RFP #16012-3806
REQUEST FOR PROPOSALS
FOR ELECTRICAL SERVICE PROVIDER FOR THE
RICHLAND CREEK RESERVOIR, ETOWAH RIVER RAW WATER INTAKE,
WATER TREATMENT PLANT, AND RESERVOIR PUMP STATION
Paulding County, Georgia
Richland Creek Water Supply Program

ADDENDUM #1

April 5, 2016

SITE PLAN - RIVER INTAKE

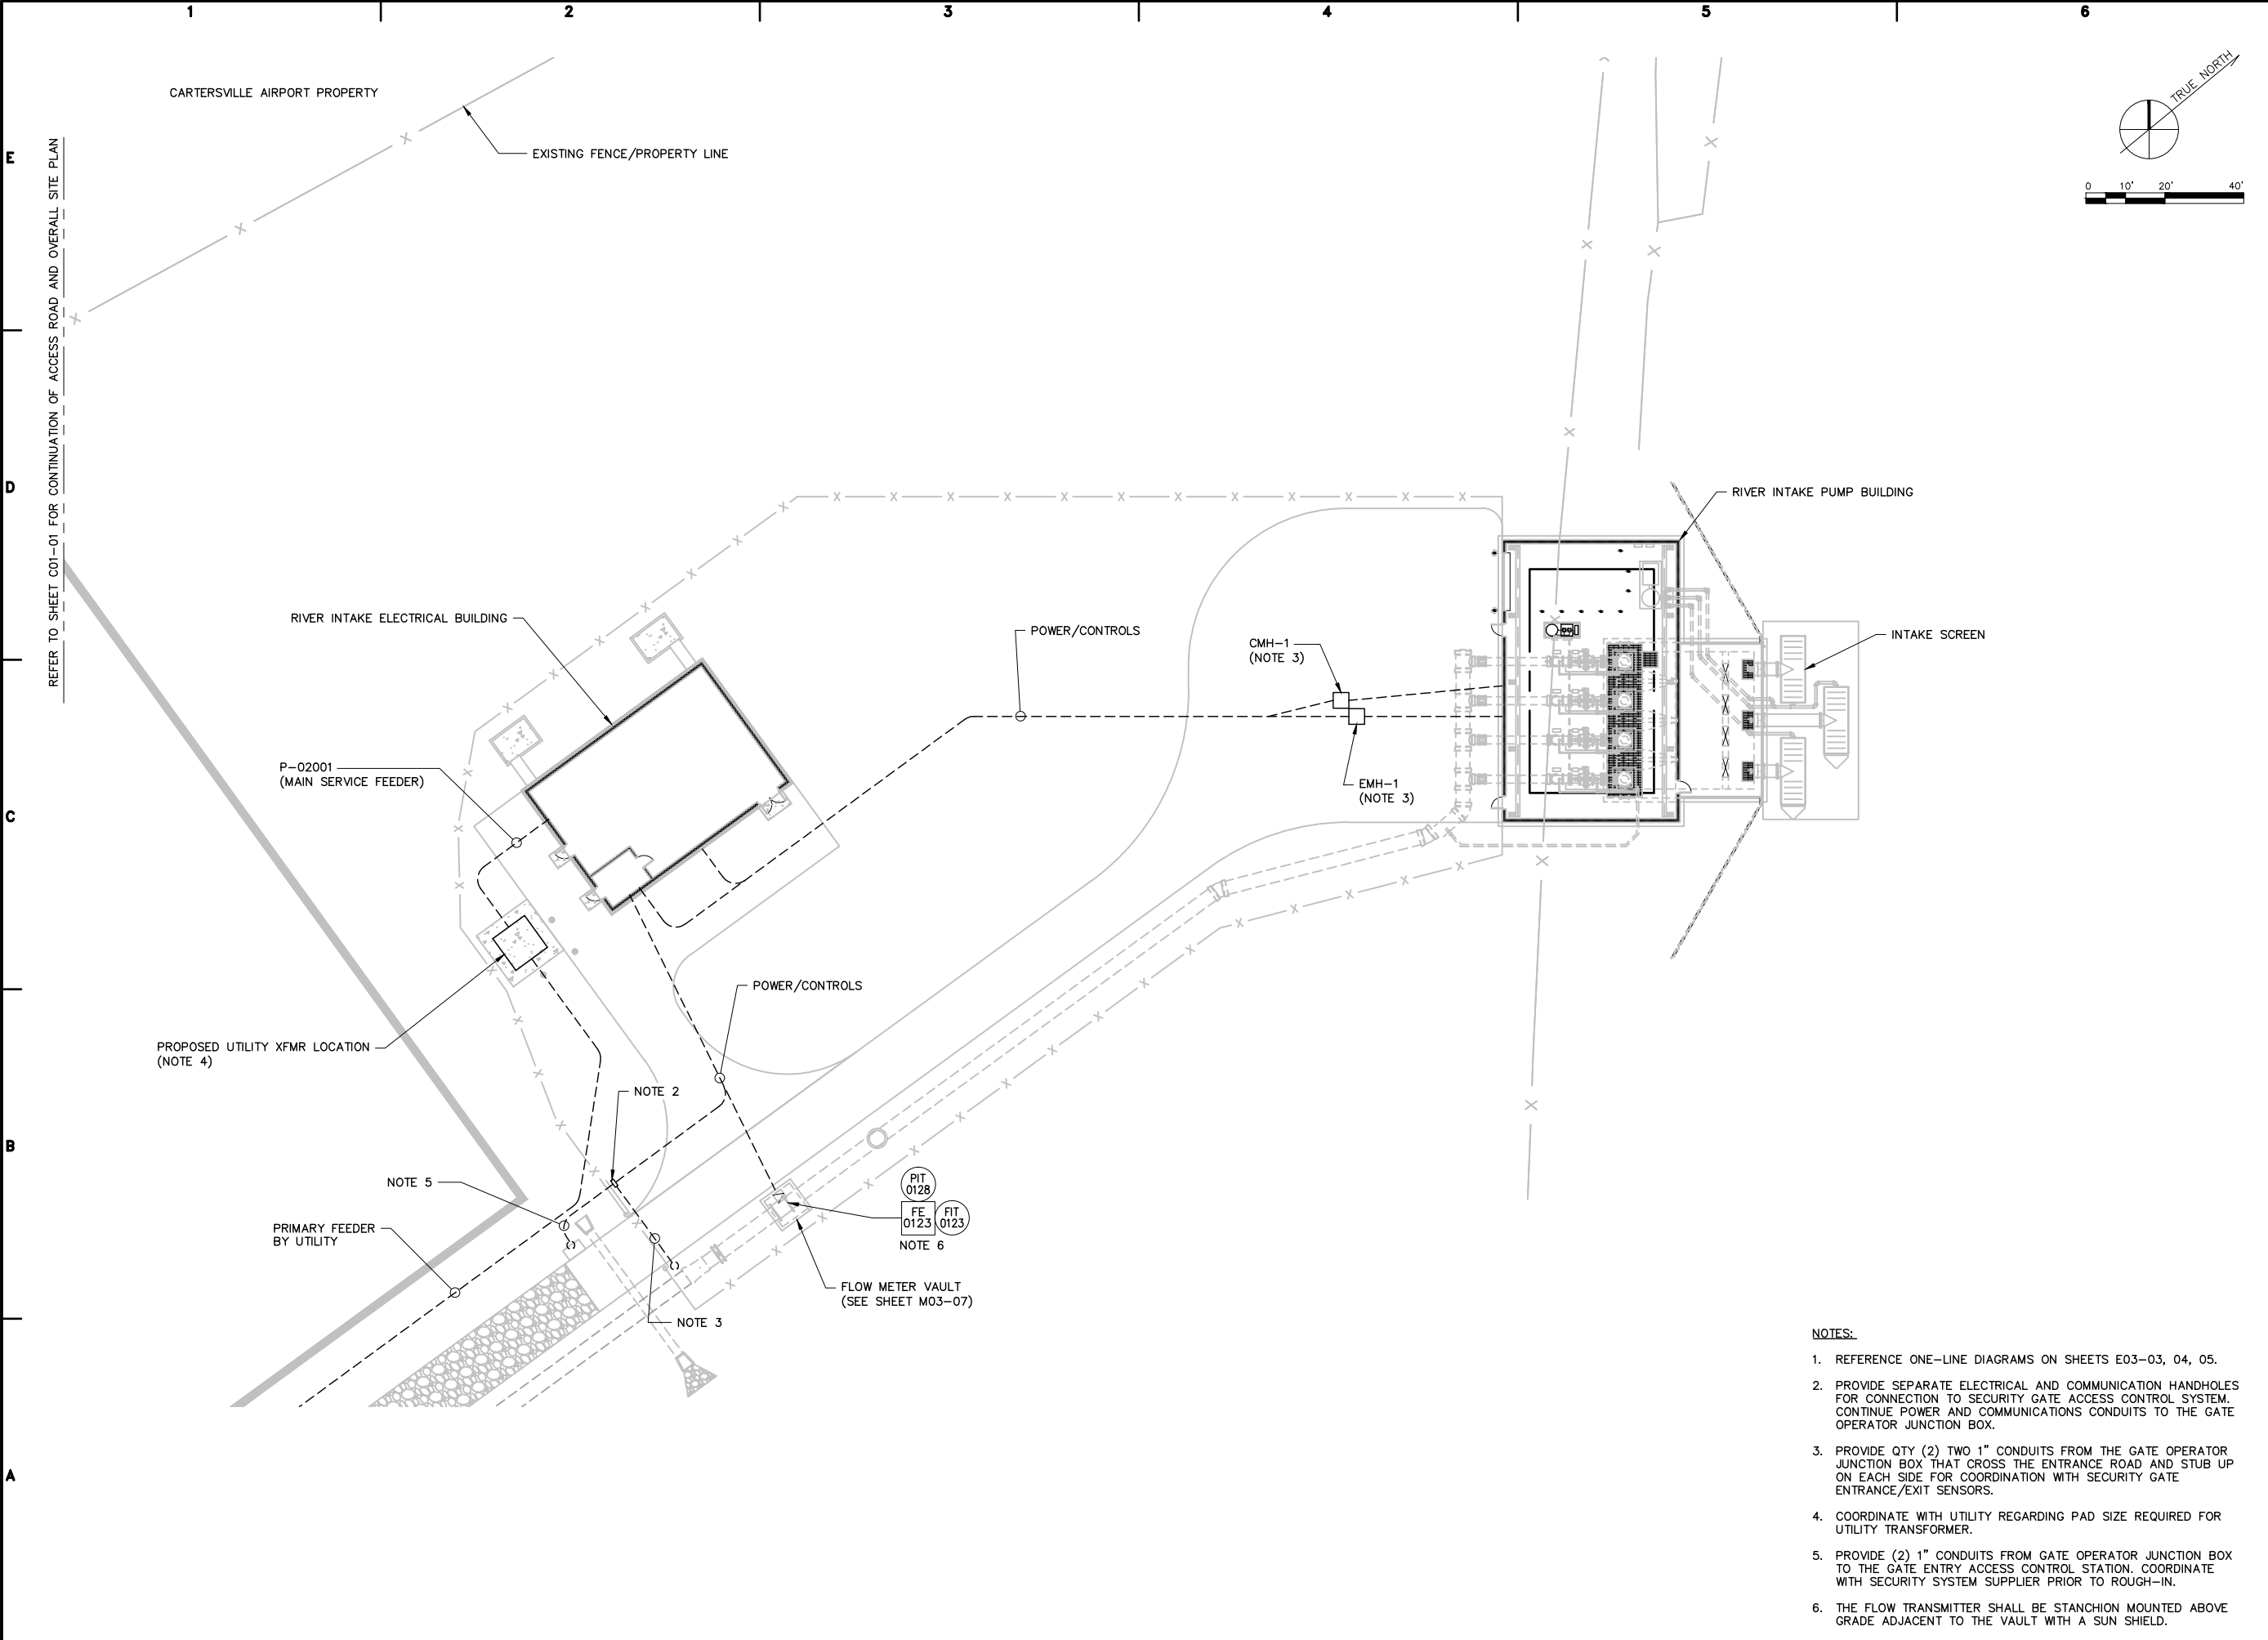
1. **Question:** Can we receive in CAD format the site plan for the two locations?

Answer: Yes, Issued with this Addendum are PDF drawings of the electrical site plans for the two site showing the locations of the planned utility transformers. CAD files will be provided if desired – contact Lori Cirami (information above) and she will transfer you the files in CAD format.

SHEET TITLE
ELECTRICAL
SITE LIGHTING PLAN
(1 OF 2)

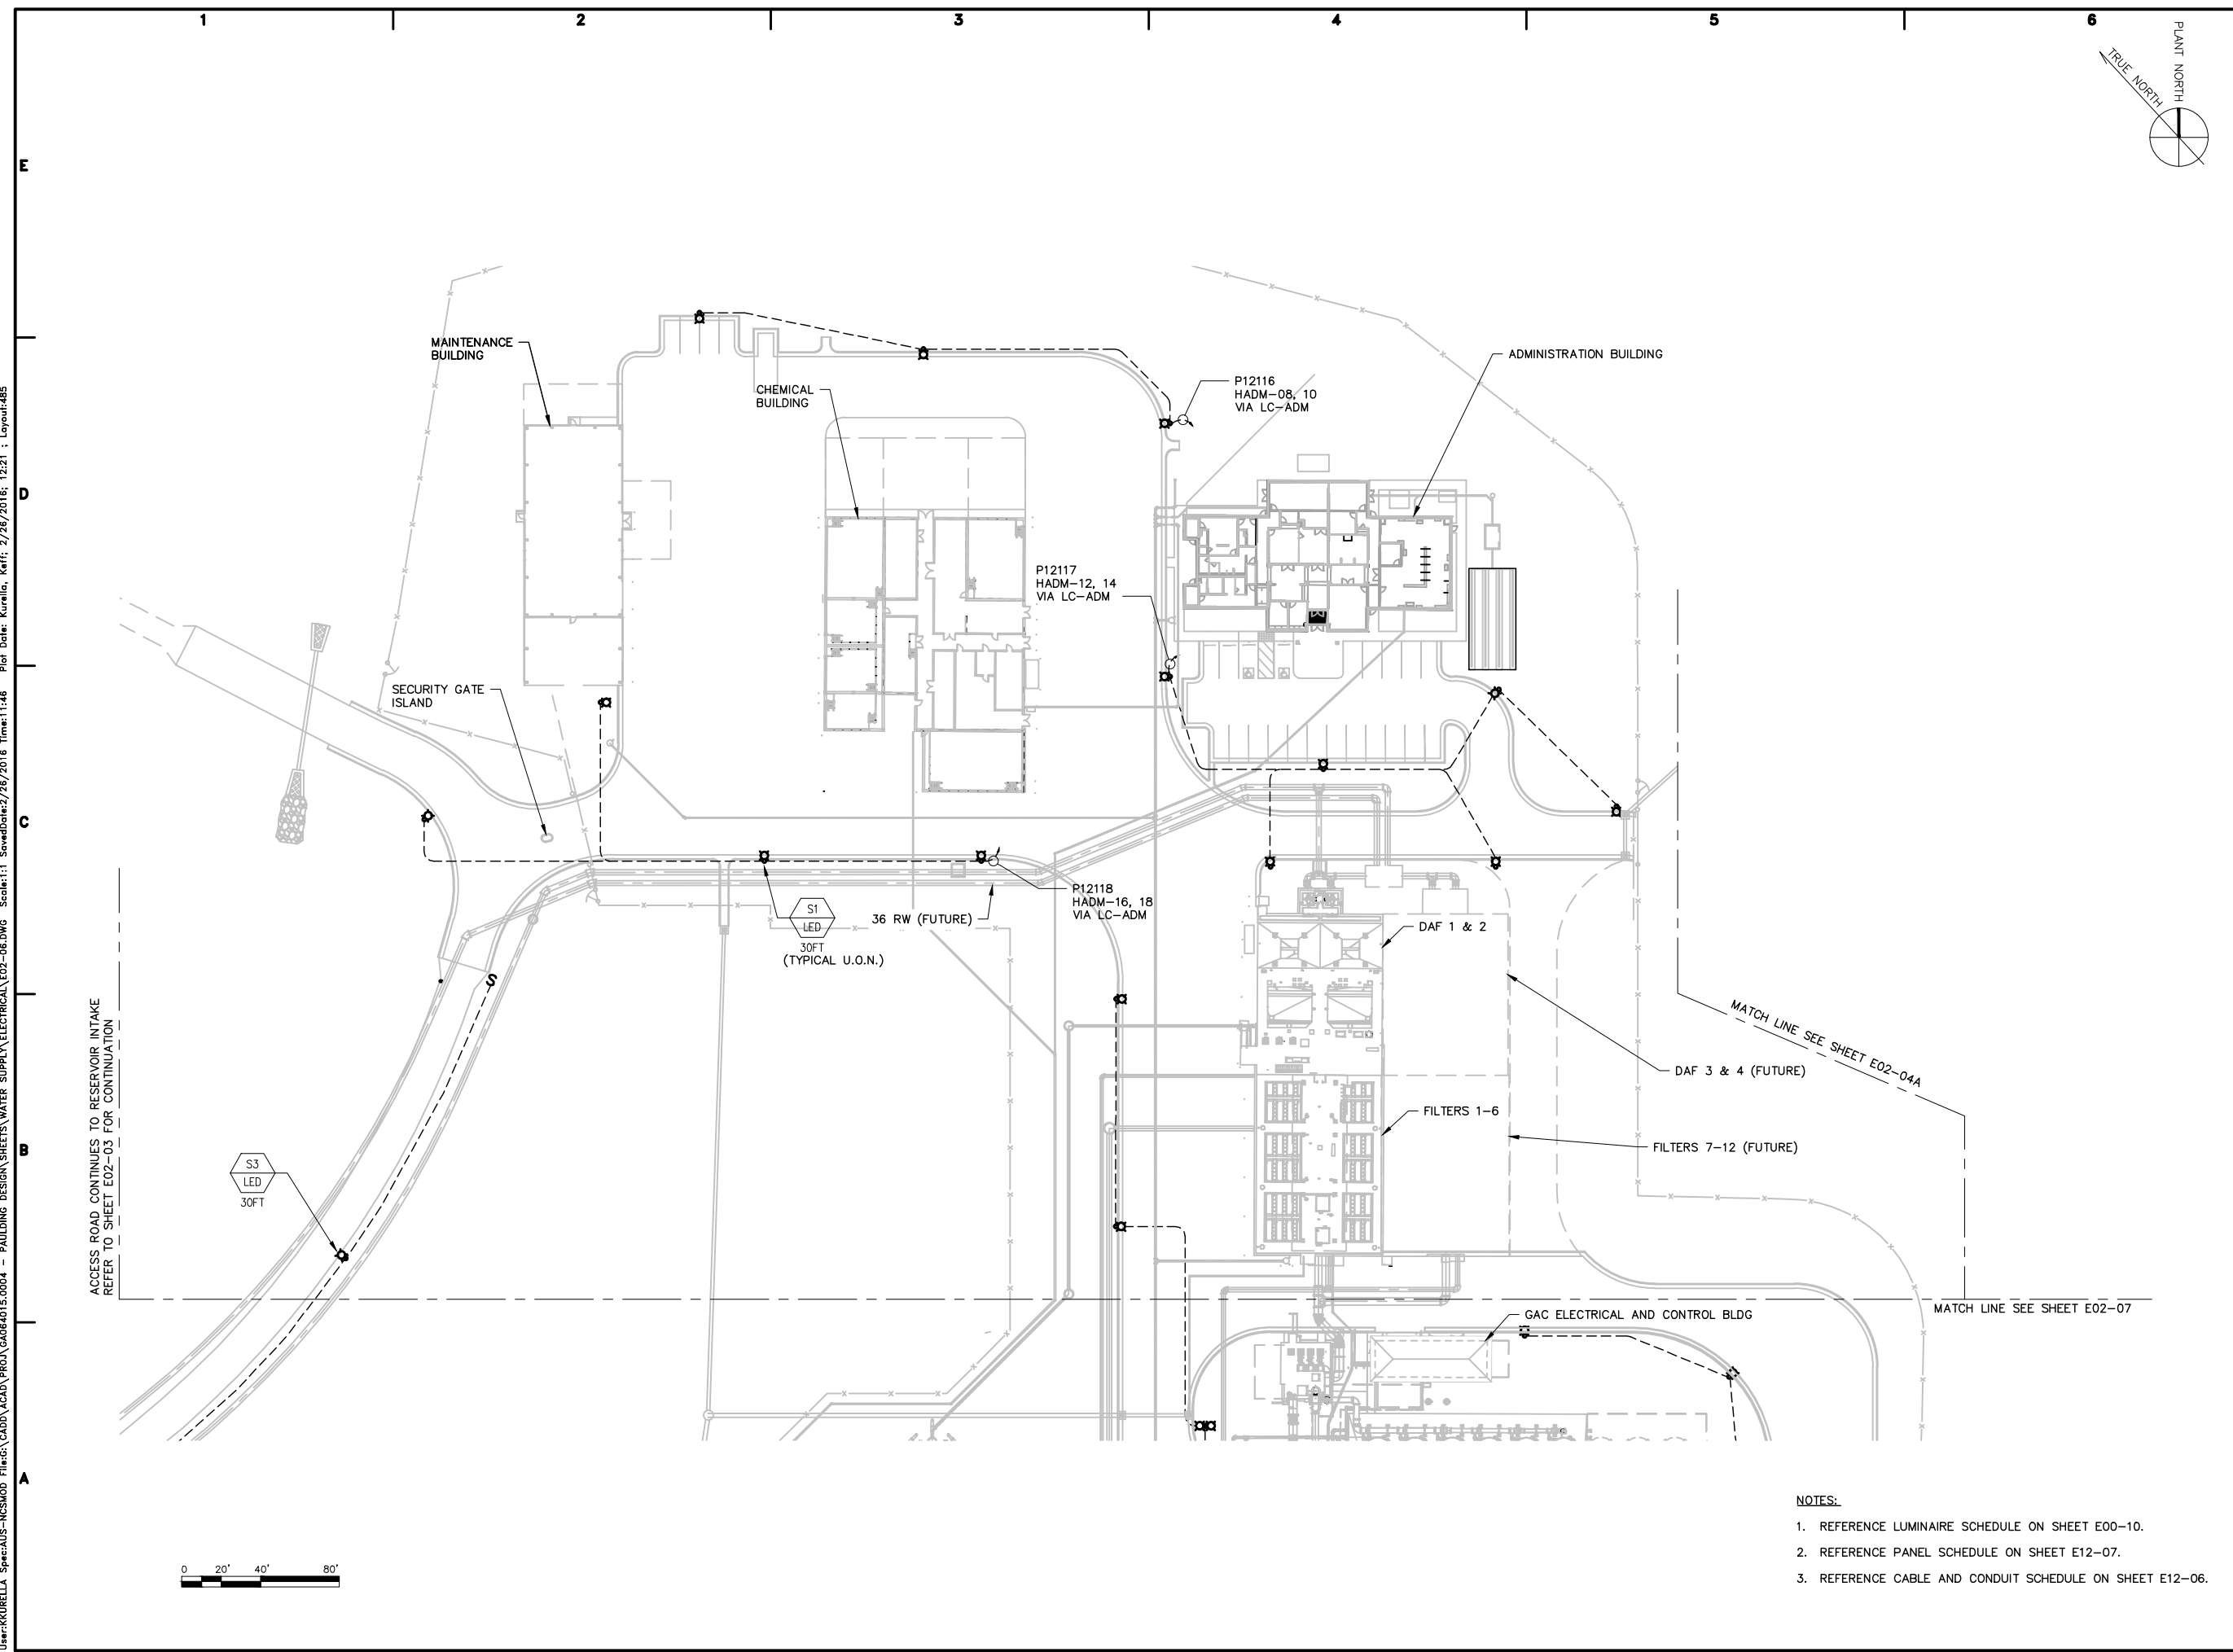
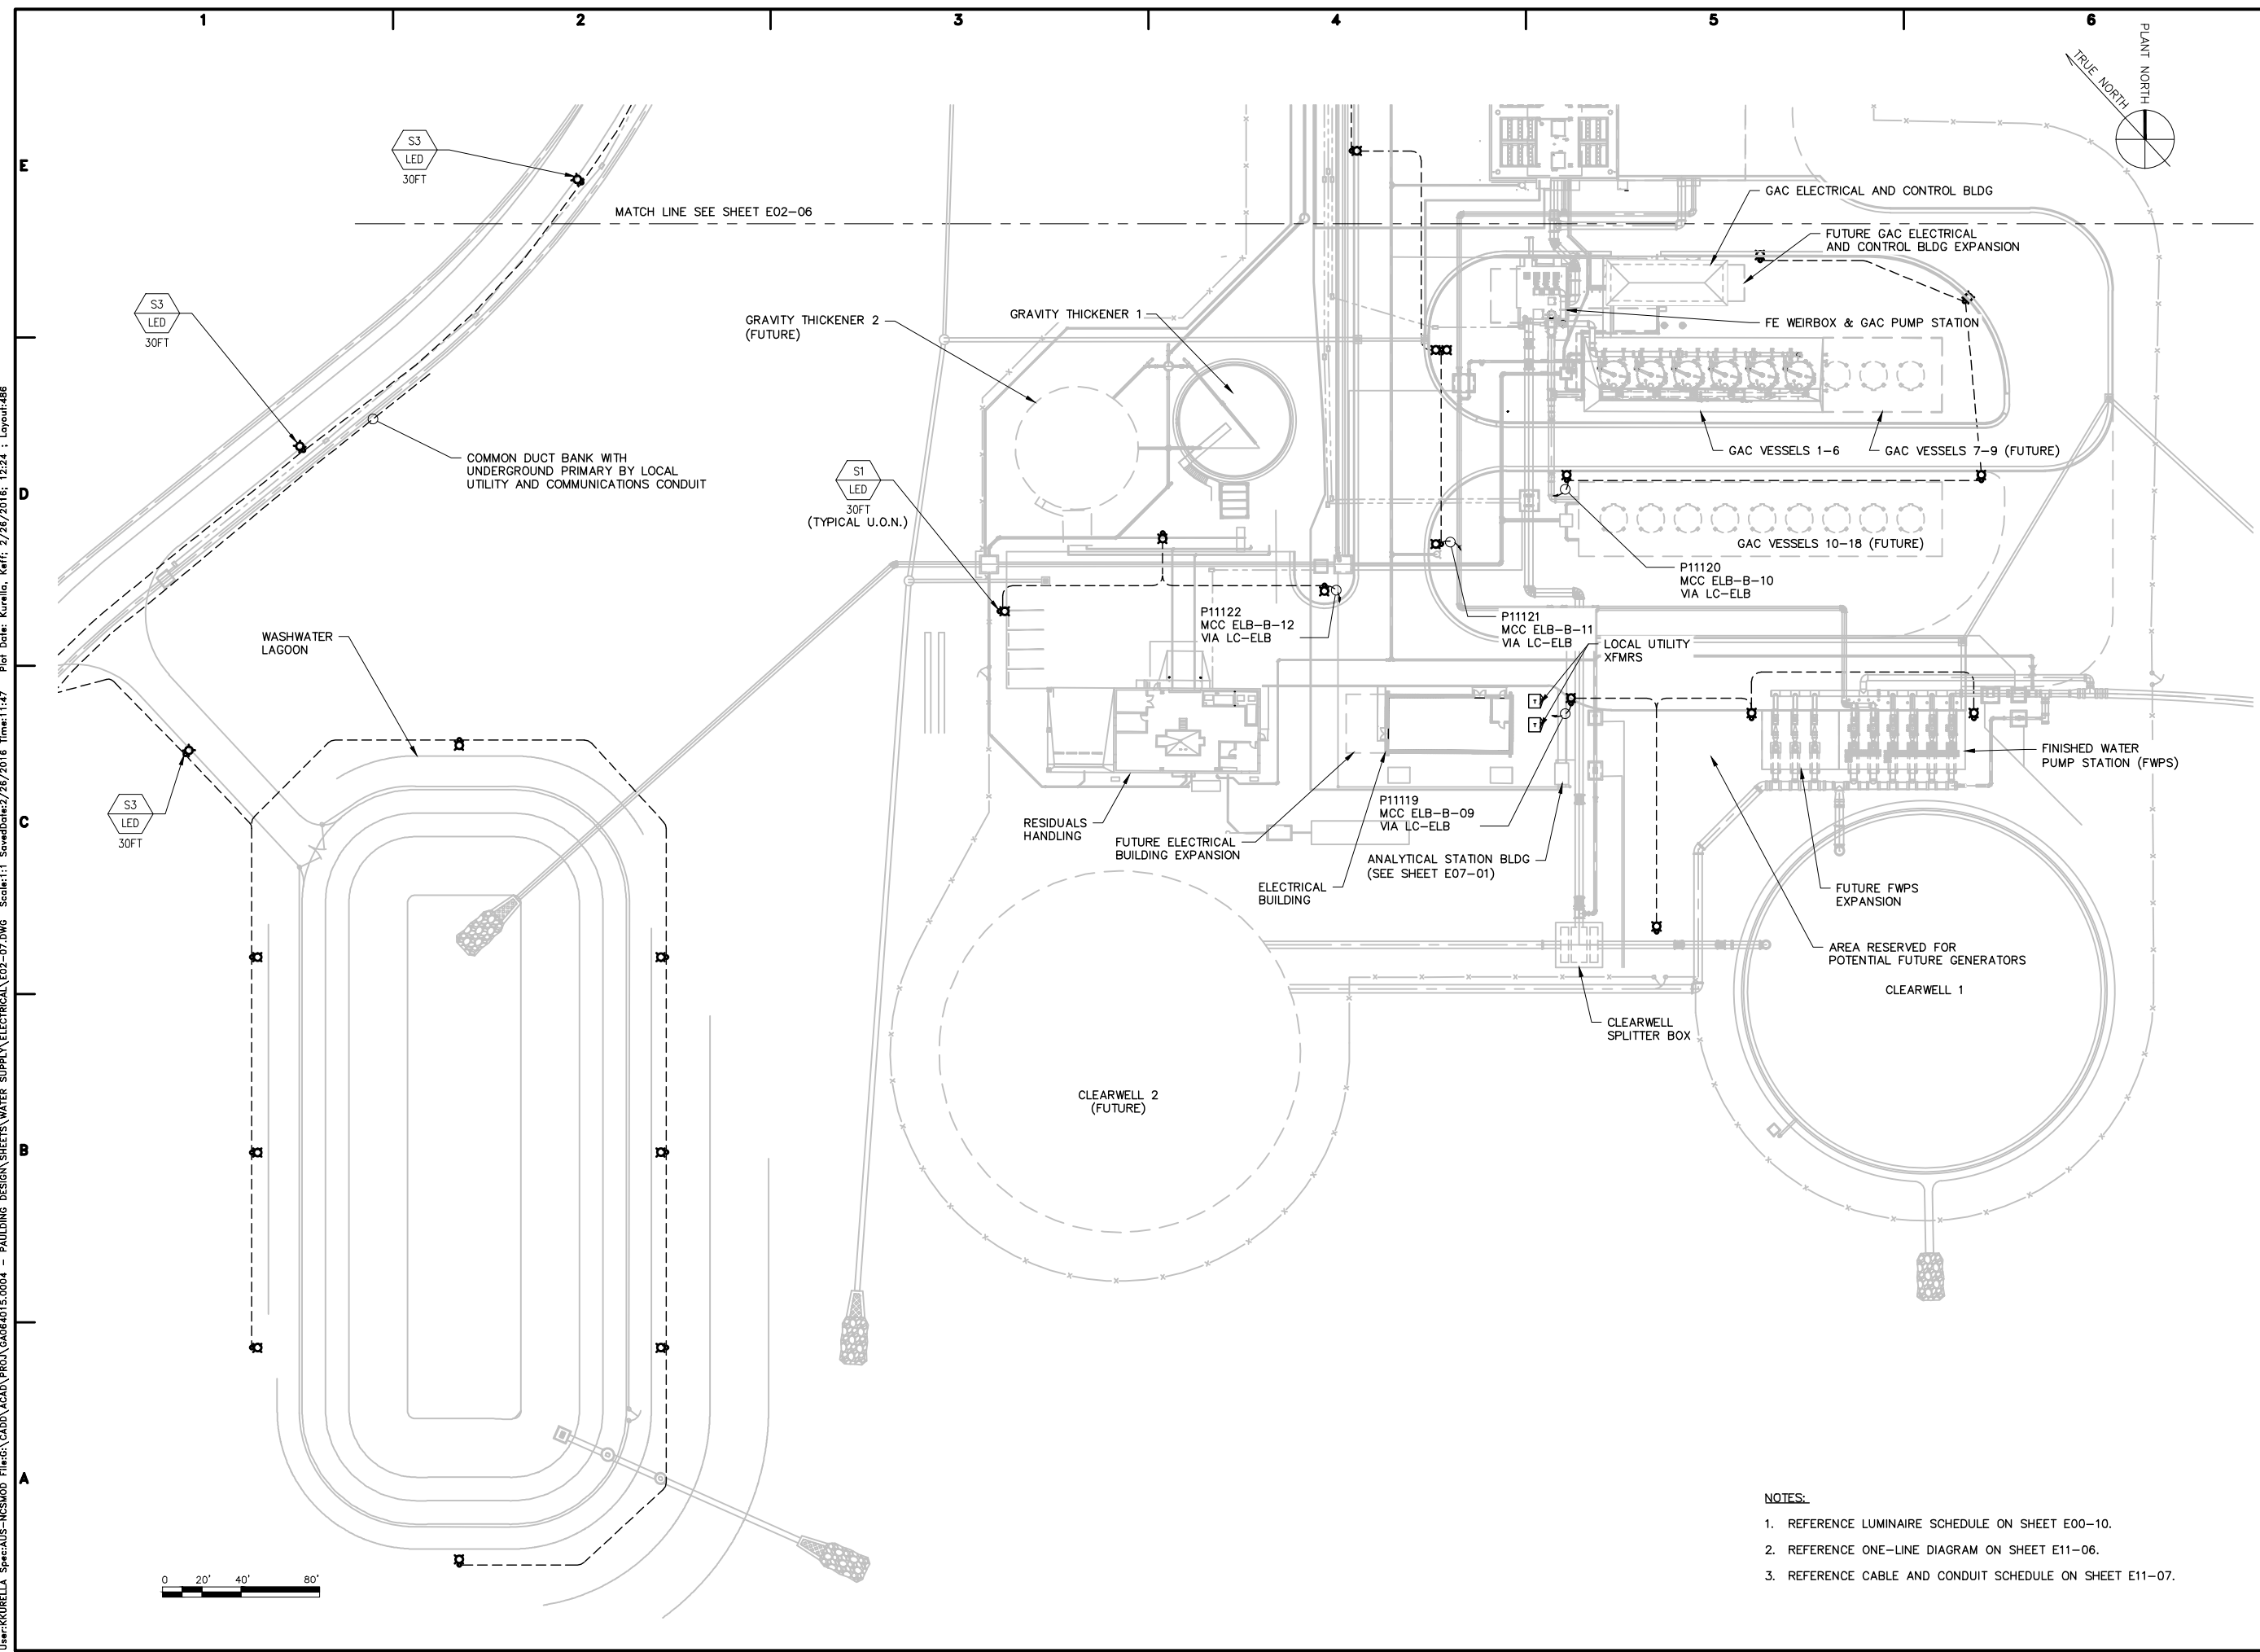
6. **Question:** Please provide details on roadway and parking lot lighting. Is there a design already in place?

Answer: The electrical contractors will provide roadway and parking lot lighting as part of the WTP design. PDFs of roadway lighting are attached.
